Application of Friends of St. Patrick's Episcopal Day )  
School LLC pursuant to 11 DCMR § 3104.1 for a Special )  
Exception for a Theoretical Lot Subdivision and a Private ) No. 17429  
Middle and High School in the R-1-B District at Premises )  
1801 Foxhall Road, N.W. (Square 1346, Lots 825, 826, )  
and 827). )  
\_\_\_\_\_ )

**REQUEST FOR PARTY STATUS**

**Response to Comments of Friends of St. Patrick's School  
Regarding the Alternate Development Plans of the  
Colony Hill Traffic and Access Subcommittee**

Diagram 5a: Revised tract plan  
plan (residences 2-5 facing  
south)

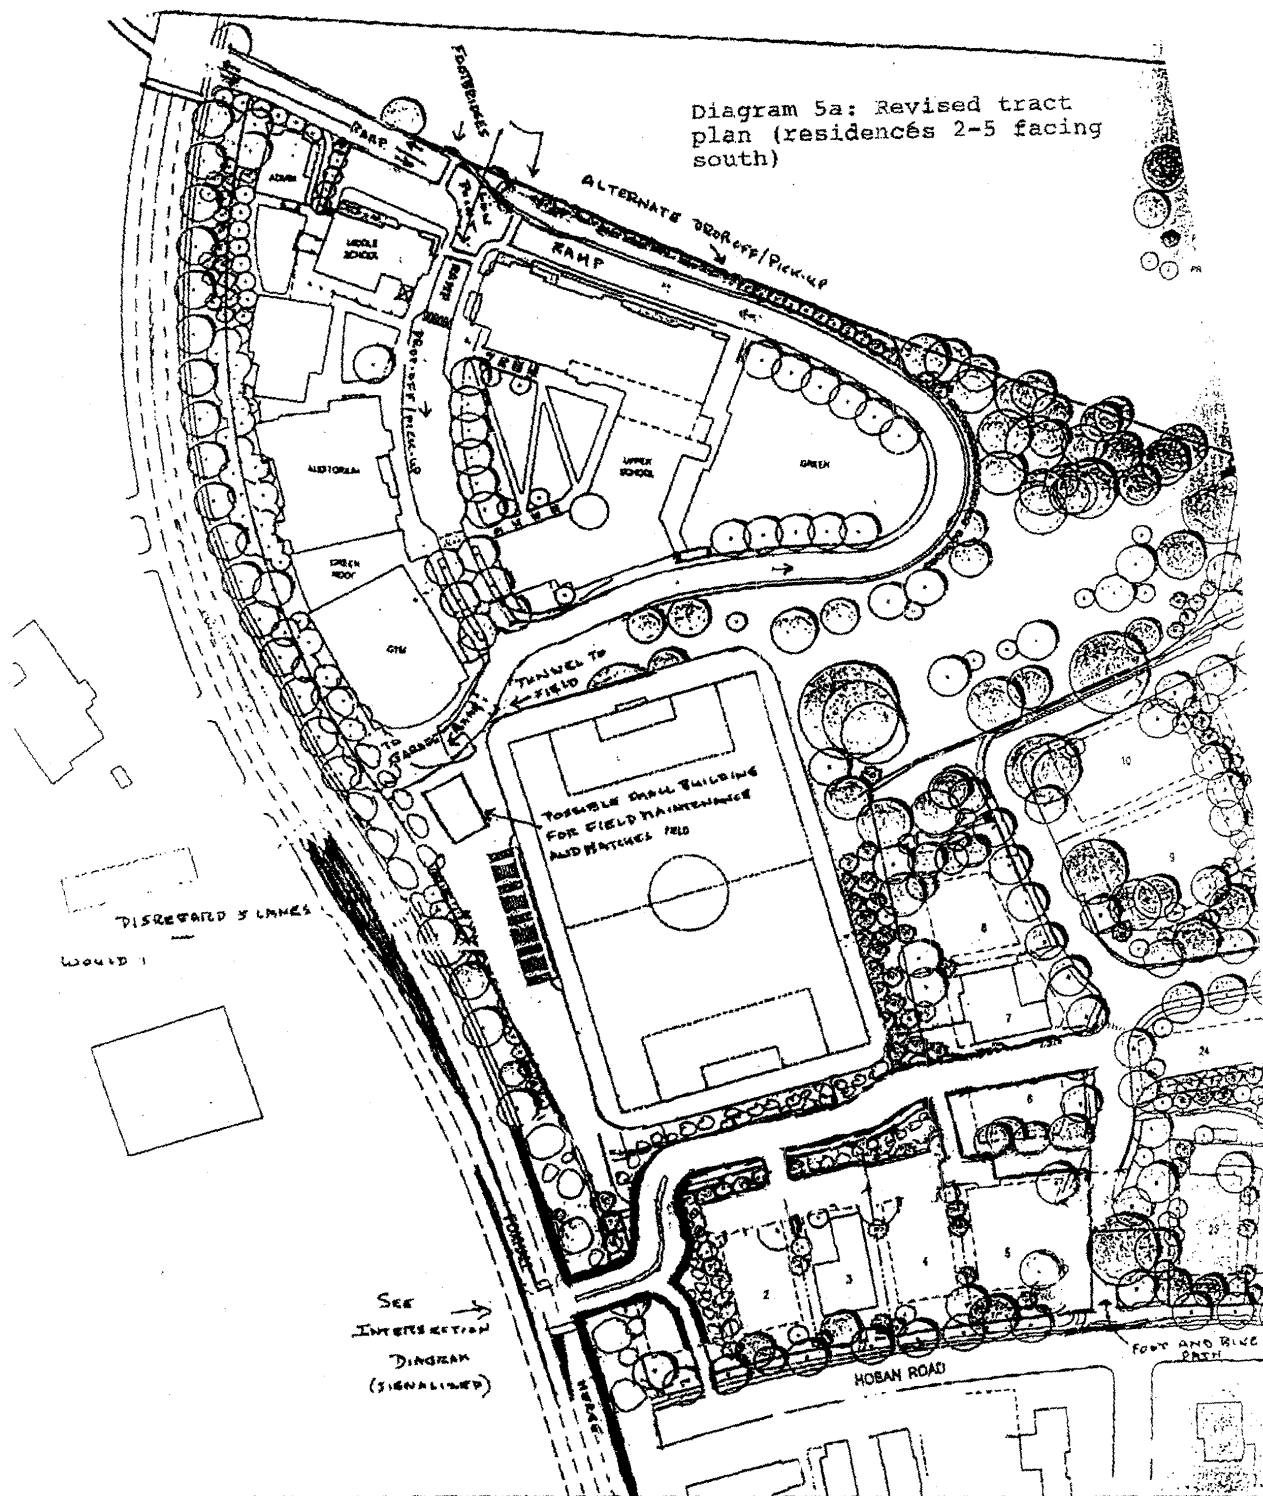
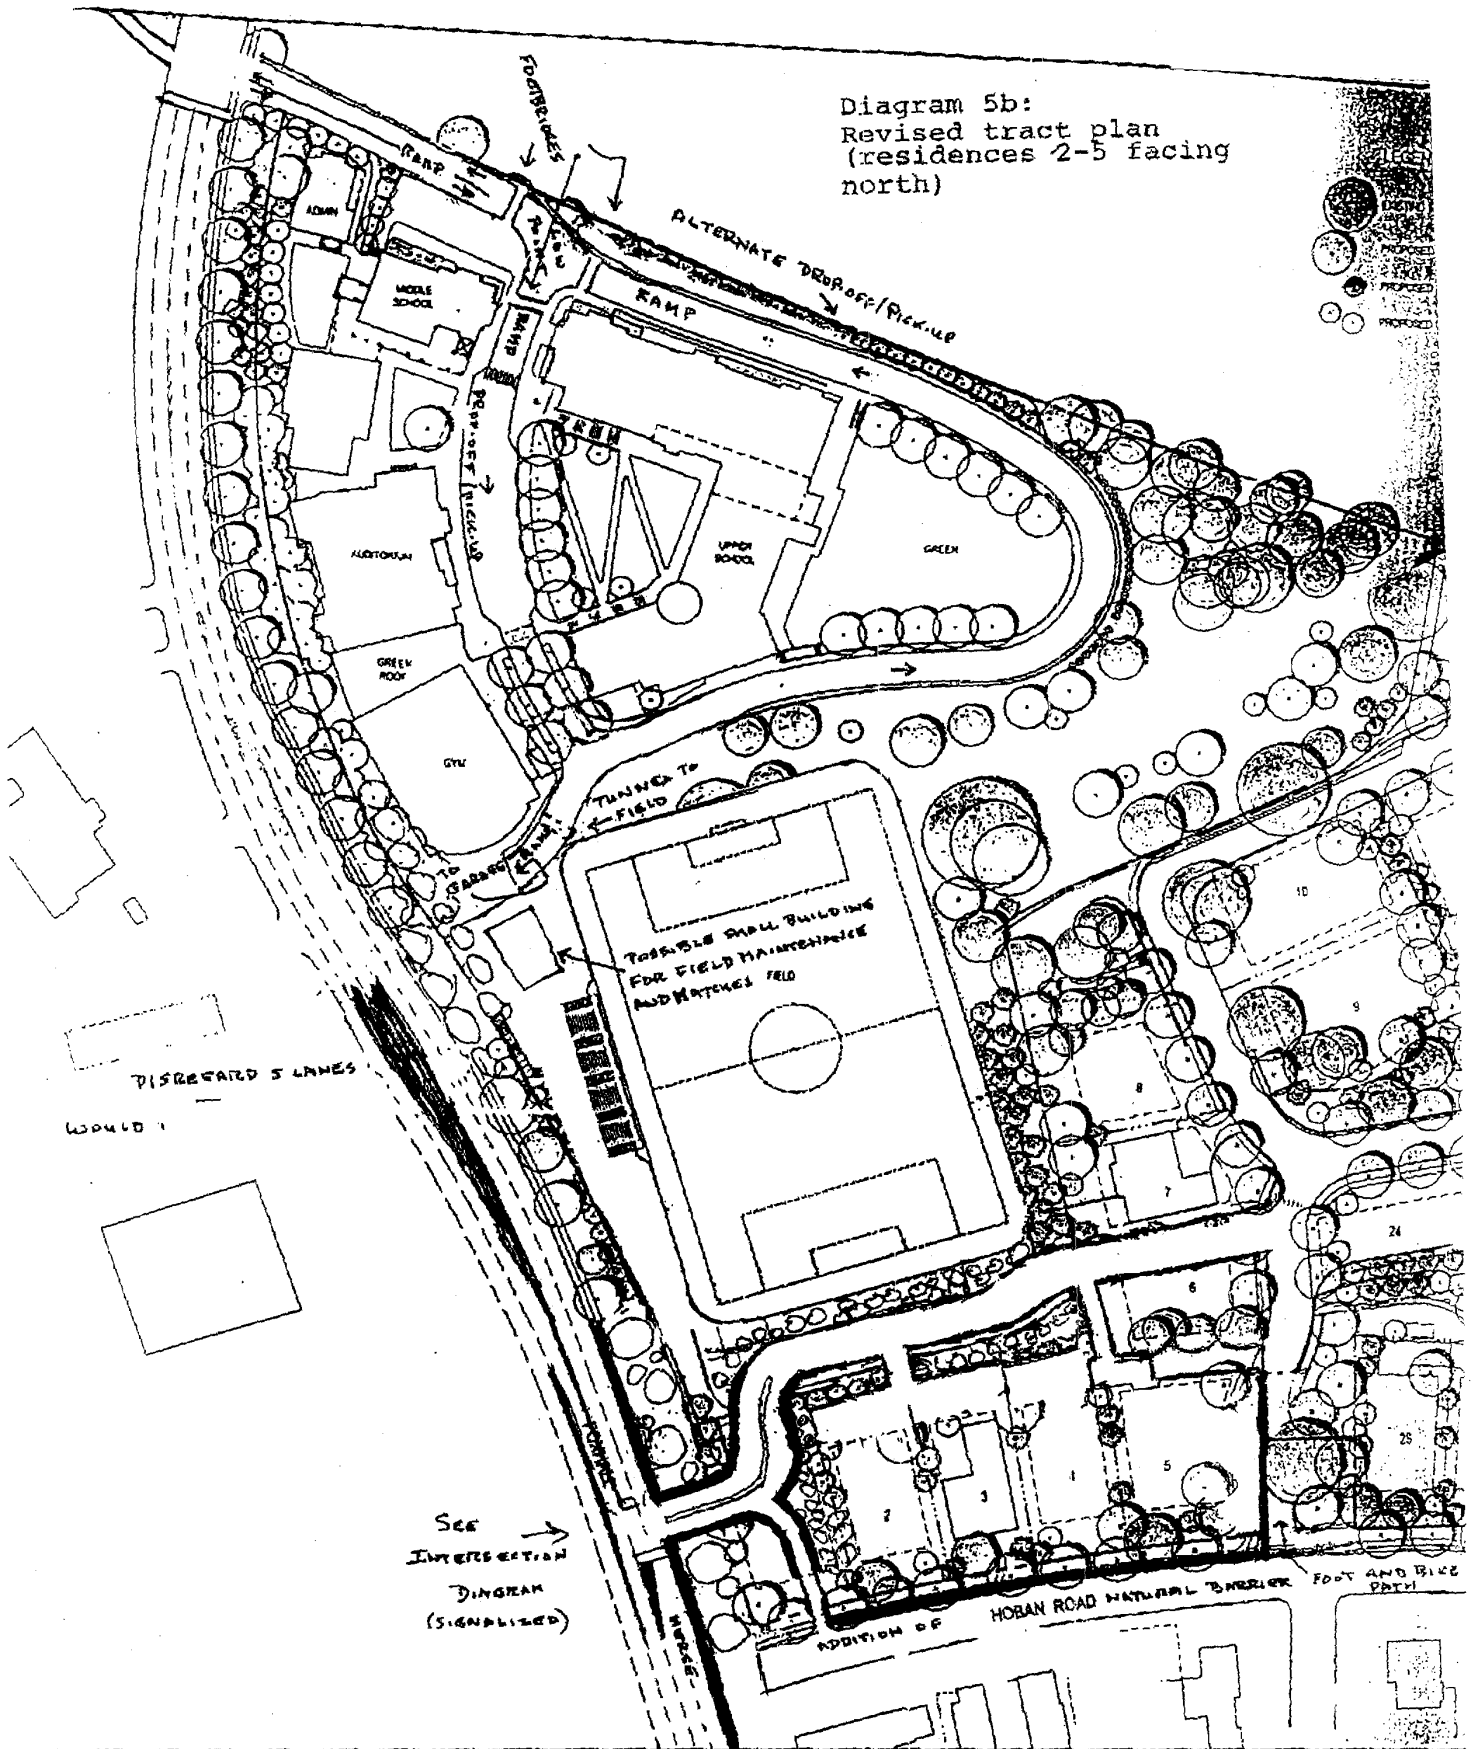
*The [Subcommittee's plan] creates a separate enclave out of the new Residential Development. This violates the sound planning principles followed in Washington DC and promoted by the Office of Planning.*

*The [Subcommittee's plan] makes no attempt to integrate the proposed development's road network into the existing road grid of Washington D.C.*

*The [Subcommittee's plan] forces the first four or five houses in the Residential Development to be constructed on double-frontage lots, which is both confusing and poor planning.*

*The [Subcommittee's plan] creates confusion and raises safety questions. For example, an unfamiliar driver potentially could turn in, get confused, and stop at the split in the new road. The [Subcommittee's plan] only provides room for one other car behind it. Therefore, one lost driver could quickly cause a back-up that could spill onto Foxhall Road.*

*The [Subcommittee's plan] would require dropping two lots; #1 to allow the new, forced access road and #6 to allow the access road down into the loop road within the new Residential Development. This increase in density would result in more difficult grading and the loss of seven to nine special trees, including a few of the large conifers above the now-pressured lots ## 7 and 8.*

Yes it does. The Subcommittee's plan integrates that road network into the existing road grid of Washington D.C. at a designated entrance/exit point on Foxhall Road. The Subcommittee's plan does not, however, attempt such integration by connecting with the

In the Subcommittee's original Diagram 5a, the houses in question would front on Hoban Road. In the rear, they would be serviced by an alley and would be separated by the road in back by a thick hedge or other natural barrier. Given that only 24 or so other houses would be using that road in back, effects from that traffic would largely go unnoticed.

The Subcommittee expects that, if the entrance/exit to the new Residential Development were placed on Foxhall Road in accordance with initial and Revised Diagram 5a, the developers of that new residential tract would clearly have its entrance presented in a very elegant and exclusive way, thus discouraging the general public from entering. Thus it is unlikely that any driver would turn in there without being familiar with that entrance/exit. If that did happen, the driver would proceed into the new entrance and either go right into Colony Hill or go left into the new development. Either way, this scenario is no different from a lost driver turning off an arterial road onto a street and suddenly realizing that he did not know where he is. If he can't turn around immediately – which he couldn't at the entrance/exit advocated by the Subcommittee – he would

The Subcommittee's plan would require dropping only lot #1 to create the entrance/exit for the Residential Development. As shown on initial Diagram 5a, lot #6 would continue to exist. It would merely be relocated so that it is south of the Subcommittee's entrance/exit road rather than north of the service alley in FOSP's proposal. There would be no increase in density on the tract. If anything, the Subcommittee's original Diagram 5a would allow lots ## 2, 3 and 4 to be greater in north-south length and lot #5 to be

greater in east-west width when compared to FOSP's proposal. As a result, housing density would be less in the Subcommittee's original plan than in FOSP's proposal. These advantages are even more pronounced in the Subcommittee's revised Diagram 5a, discussed below.

DIAGRAM 3  
(Revised)

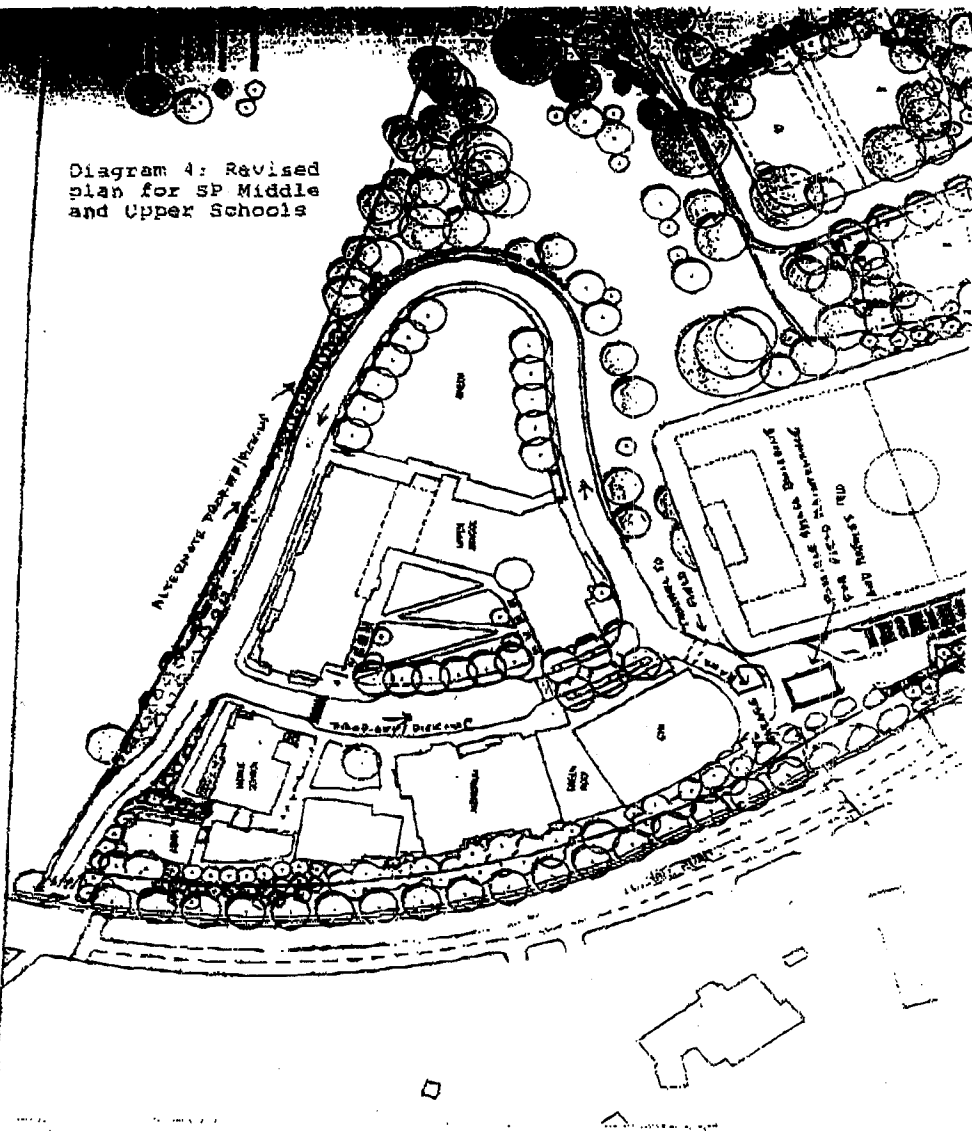
*It would be difficult, confusing, and dangerous to indicate to and force southbound Foxhall Road motorists planning to make a left turn into the middle/high school campus to actually turn right into the Subcommittee's proposed stacking lanes. While it may be possible to "train" St. Patrick's parents, students, faculty and staff, the first-time or occasional visitor to the middle/upper school campus would expect to turn left directly into the site rather than turn right into Whitehaven Parkway, make a U-turn on Whitehaven Parkway, bear right and then cross Foxhall Road. Those motorists attempting to turn left directly from Foxhall Road likely would conflict with northbound left turns or block southbound through traffic on Foxhall Road.*

In the Subcommittee's Diagram three, there are only two "road openings... from Whitehaven Parkway onto Foxhall Road." One consists of a left-turn lane from Whitehaven for traffic wishing to proceed north on Foxhall. The other consists of a right turn lane for traffic wishing to go southbound. Both "openings" would be controlled by the same light cycle and show the same red, yellow or green signals at all times – even if multiple lights were used at this intersection to assure that all motorists were receiving that signal at the same time. Beyond this, the Subcommittee does not understand FOSP's comment here.

First, the arrangement in question would be used only during hours of morning and afternoon peak traffic at the middle and upper schools. At those times, however, the Subcommittee understands FOSP's concern about "untrained" passengers wishing to turn left into the middle and upper schools. The Subcommittee doubts that there would be very many "untraineds" wishing to make this turn during the peak periods. A solution, therefore, would be to allow "untraineds" to do exactly what they are requesting: i.e., to make the turn from a middle, southbound stacking lane on Foxhall that is shown on Diagram 3. The "trained" members of the SP community, on the other hand, would be required to use the stacking lanes shown in Diagram 3. The Subcommittee assumes that FOSP would have a traffic enforcement officer stationed at this intersection to address any problems that might arise in this and other contexts.

used for eastbound traffic wishing to turn north onto Foxhall. In the Subcommittee's Revised Diagram 3, this lane would be converted to accommodate *westbound* through traffic and allow SP to use the lane on the northern side of Whitehaven for its lower school traffic. The existing eastbound lane would now be used for all eastbound traffic, but would split as it approached Foxhall to accommodate those wishing to turn north or south onto Foxhall. Please see Revised Diagram 3.

DIAGRAM 4 (REVISED)  
(4a)

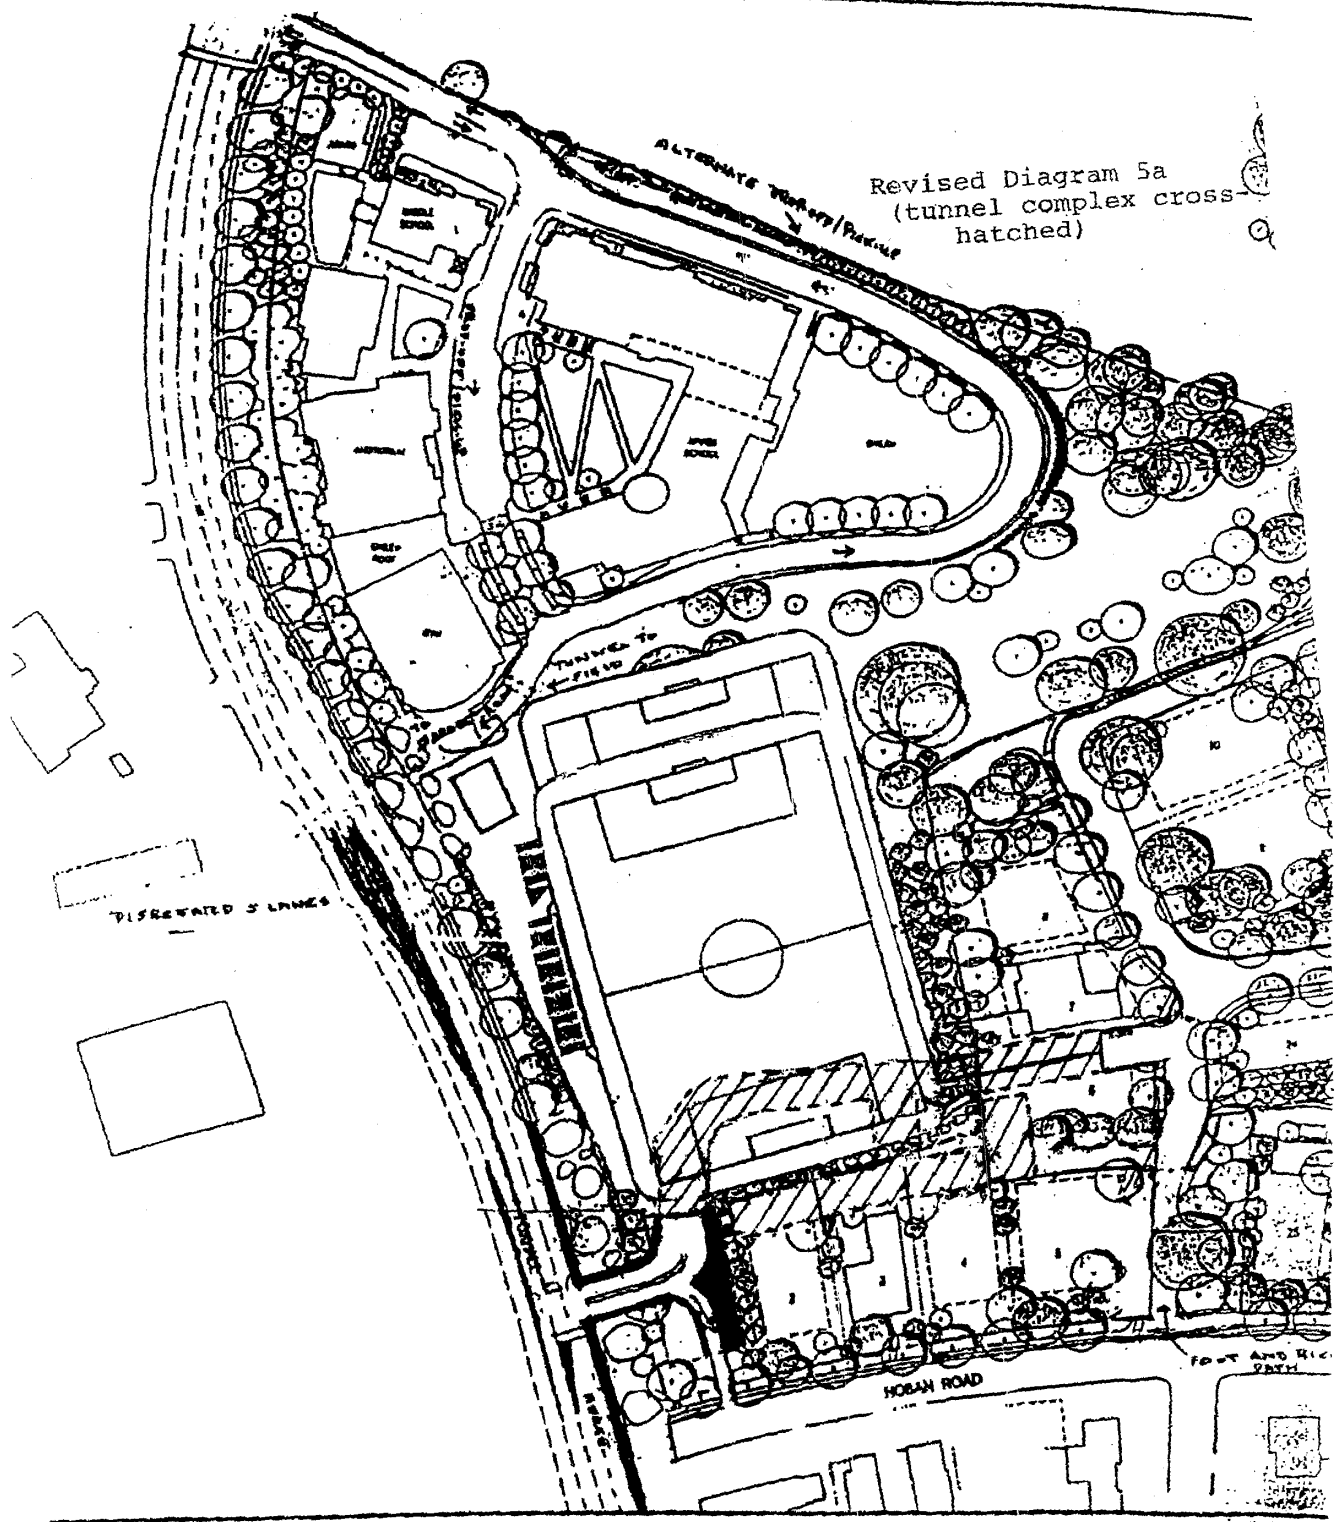
*The [Subcommittee's plan] provides very little stacking room within the single-lane loop road before the primary, safe drop-off location. Specifically, the [Subcommittee's] proposed stacking lane will be approximately 160 feet in length, and will be able to hold only six cars (at 25 feet per car).*

*Cars planning to enter the underground parking garage in the morning are forced to travel through these short drop-off/pick-up lanes, which is undesirable.*

*The [Subcommittee's plan] only provides for one lane in and out. This is contrary to the FOSP Access Plan, which provides for one lane in and two lanes out. The [Subcommittee's Plan] does not provide for separate left and right turn exit lanes. Therefore, the [Subcommittee plan] increases the likelihood that exiting traffic would back up into the drop-off zone.*

*These road grades change the grading relationship with Whitehaven Park. The [Subcommittee's...] new roadway in the NW corner will end up showing more retaining wall along that elevation. The [Subcommittee's...] roadbed is also pushed up right against the Park, leaving no room for planting outside of the walls to mitigate these views from the Park.*

*Moving the [soccer] field northward [in the Subcommittee's plan] chokes the dell down from 80 to 30 feet in width. The remaining 30 feet of the dell would be approximately 25-feet deep, thus creating a "canyon" effect that would be unsightly, dangerous and could require filling.*

The Subcommittee's plan provides more stacking room and greater flexibility in the use of stacking lanes than does FOSP's proposal. First, as noted above, the Subcommittee's plan would allow for potentially a much longer stacking lane on Foxhall Road southbound than does FOSP's proposal. Second, regarding the stacking lane on the upper/middle school campus, the Subcommittee noted in presenting its original plan to FOSP that two stacking queues – one for peak-hour traffic, one for non-peak traffic – could be used. For non-peak traffic, a shorter queue could be used that would allow automobiles to enter the middle/upper school campus and subsequently turn right into the "loop" proposed by FOSP. They would then discharge passengers at the same central point that FOSP's on-campus stacking lane would provide. This is the 160-foot stacking lane referenced in FOSP's comment immediately above.

As noted earlier to FOSP, however, the Subcommittee's plan provides for a second, much longer stacking lane for peak periods. During these periods, cars would again enter the middle/upper school campus at the Whitehaven/Foxhall intersection and turn right into the Loop road. This time, however, they would not be allowed to stop at the central drop off point. Rather, they would be required to go around the loop and drop off passengers on the northern or northeastern part of the loop – wherever the school desired. In this way, this expanded on-campus stacking arrangement could accommodate as many if not more automobiles during peak periods than is being proposed by FOSP.

In the Subcommittee's original and revised Diagram 4a, the entrance to the garage would be moved from its location from its location in FOSP's proposal: i.e., immediately adjacent and north of the proposed middle school. The Subcommittee would place it immediately south of the proposed gym. Both locations would be accessed from and feed back into the Loop road.

Here again, FOSP's comment only illustrates an advantage of the Subcommittee's plan. Under FOSP's plan, two exit lanes are needed because the exit is so close to the central pick-up/drop-off point that back-ups to that point would happen frequently without the two exit lanes. By contrast, the Subcommittee's pick-up and drop-off points are much farther from the exit point at the Whitehaven and Foxhall intersection. For non-peak hours, automobiles using the central pick-up/drop-off point would be required to traverse the Loop road before exiting. So no backup is realistically possible. For peak hours, the alternate pick-up and drop-off point on the northern side of the loop could be positioned sufficiently far to the east or southeast to avoid any backup problems from automobiles waiting to exit the campus at Whitehaven/Foxhall.

To further facilitate the exiting of cars under the Subcommittee's plan, the Subcommittee has added a service lane for exiting traffic going northbound on Foxhall Road. This lane would permit several northbound cars to move into this lane before merging with Foxhall traffic. This service lane eliminates the need for a second exiting lane from the school. when combined with a left-turn-only phase in the light cycle for traffic exiting

The first two sentences in this comment are vague and unsubstantiated, and it is difficult for the Subcommittee to ascertain whether FOSP is alleging any negative effects from the Subcommittee's plan that are at all significant. Do the referenced "road grades" refer to the ramps in the Subcommittee's original Diagram 4a? As noted, they have now been eliminated. Even if the "road grades" refer to something else, the Subcommittee is uncertain how much FOSP believes grading relationship will "change" and what kind of change will be brought about. For all that can be discerned, any changes may be minimal or even positive.
